**Re: Request for additional drill 53 holes to be amended to current Variation of Authorisation 0731-01 and Mining Management Plan (2023 MMP)**

Response to Variation to Authorisation 0731-01 - Attachment A comments raised by DITT and the Supervising Scientist (Department of Climate Change, Energy, the Environment and Water)

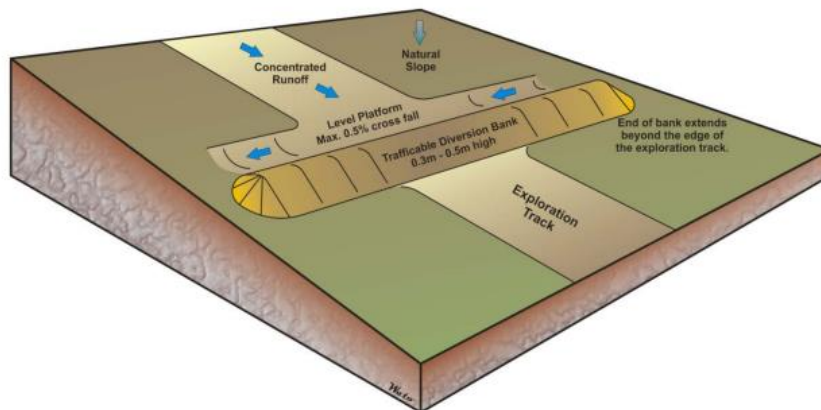
**Item 14 and 15.** Tracks where drilling was unsuccessful will be rehabilitated. Where drilling has been successful tracks will be retained for the following season. To mitigate the risk of erosion and the loss of knowledge with time DevEx will adopt the following practices

1. Similar to the Drill Hole Rehabilitation Register, DevEx will create and Exploration Track Register which identifies tracks establishes during the year by name.
2. The name of these tracks will be recorded as a GIS file for reference.
3. Rehabilitated track will be recorded in a similar way to the Drill Hole Rehabilitation Register
4. Tracks not rehabilitated on account of them being required for the following year will be noted on the Track Rehabilitation Register. To minimise the risk of soil erosion by implementing erosion control techniques, such as erosion control structures including diversion banks or whoa-boys (Figure below), placed at suitable intervals.
